Access Compliance Report

Public Rights-of-Way

(Curb Ramps)

Intersection ID: 28401	Main Street: WADE_ARDREY_RD	Cross Street: MARVIN_RD	Location: NE
ADA ID: EB410D098FA1	Ramp Type: BlendTrans2	Initial Pass/Fail: Fail	Overall Compliance: No
			Severity Score: 21.25

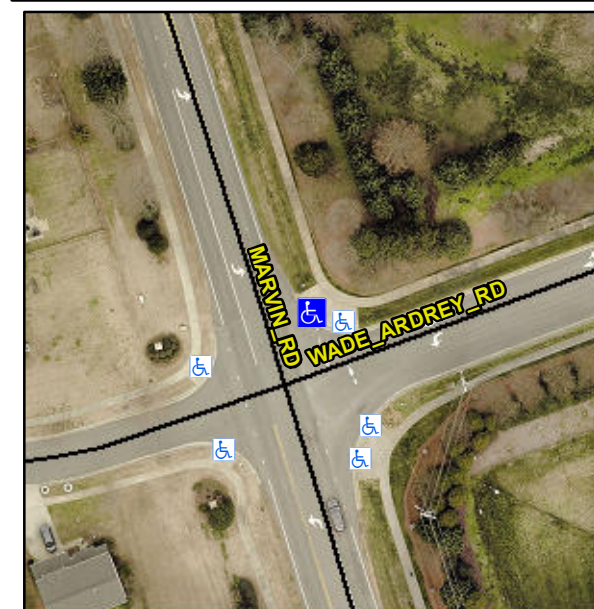
Not Found, R304.5.1, R304.5.3

Compliance	Description	Data	Compliance	Description	Data
N/A	Ramp Length (in)	155.0	Yes	BlendTrans Slope (%)	0.0
No	Ramp Width (in)	38.0	No	BlendTrans XSlope (%)	5.2
N/A	Flare Type LT	N/A	N/A	Flare Type RT	N/A
N/A	Flare Slope LT (%)	N/A	N/A	Flare Slope RT (%)	N/A
N/A	Flare Traversable LT?	N/A	N/A	Flare Traversable RT?	N/A
N/A	Landing Length (in)	N/A	N/A	DWS Provided?	N/A
N/A	Landing Width (in)	N/A	N/A	DWS Contrast?	N/A
N/A	Landing Slope (%)	N/A	N/A	DWS Length (in)	N/A
N/A	Landing X Slope (%)	N/A	N/A	DWS Full Width?	N/A
N/A	Landing Curb? (Y/N)	N/A	N/A	DWS Offset (in)	N/A
N/A	Shared Landing?	N/A			
N/A	Gutter Ponding?	N/A	N/A	Gutter Slope (%)	N/A
N/A	Gutter Lip Ht (in)	N/A	N/A	Gutter X Slope (%)	N/A
N/A	Painted X Walk1?	No	N/A	Painted X Walk2?	N/A
	X Walk 1 Direction	To SW		X Walk 2 Direction	N/A
	X Walk 1 Width (in)	N/A		X Walk 2 Width (in)	N/A
	X Walk 1 Slope (%)	6.1		X Walk 2 Slope (%)	N/A
	X Walk 1 X Slope (%)	1.4		X Walk 2 X Slope (%)	N/A

N/A	Ramp inside XWalk1?	N/A	N/A	Ramp inside XWalk2?	N/A
	Road Slope (%)	1.4		Clear Space?	N/A
	Road X Slope (%)	6.1	N/A	Clear Space to XWalk (in)	N/A
N/A	Any Obstructions?	N/A	N/A	Storm Grate/Utility Hazard?	N/A
	Obstruction Type			Storm Grate/Utility Type	
		N/A			N/A
			Yes	Surface Condition? (G/P)	Good
			No	Curb Slope (%)	22.7

Remove & Replace Curb Ramp With Two New Directional Ramps or Equivalent.
